Advisory Action Before the Filing of an Appeal Brief	Application No. 10/045,467	Applicant(s) CHAN ET AL.	
	Examiner LUN-YI LAO	Art Unit 2629

THE REPLY FILED 17 January 2007 FAILS TO PLACE THIS APPLICATION IN CONDITION FOR ALLOWANCE.

Fig. 6(h)

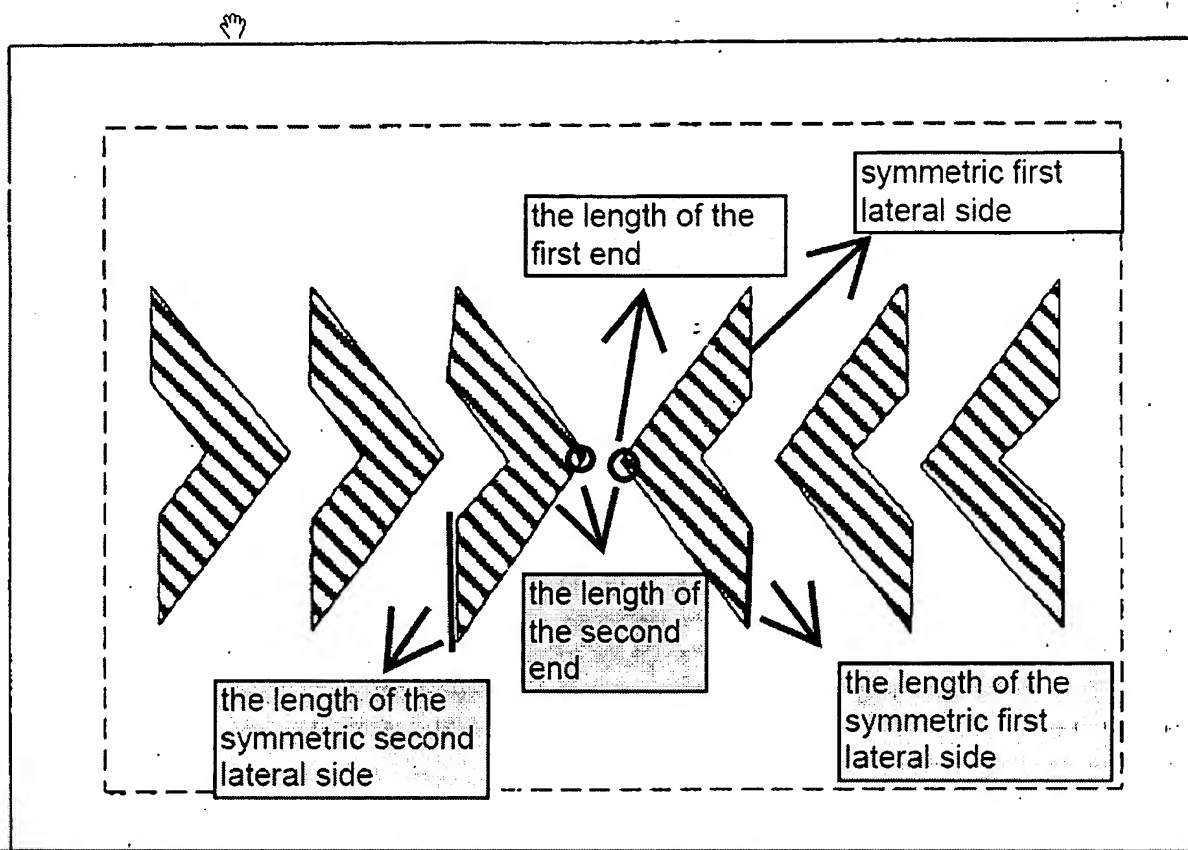
Continuation of 11. does NOT place the application in condition for allowance because: Kim et al teach four electrodes disposed on the first substrate and at corners of each display cell(see figures 4-6) and Liu teaches the length of the first end is less than the length of the two symmetric first lateral sides(see figure 6(h)(see final rejection and attachment).
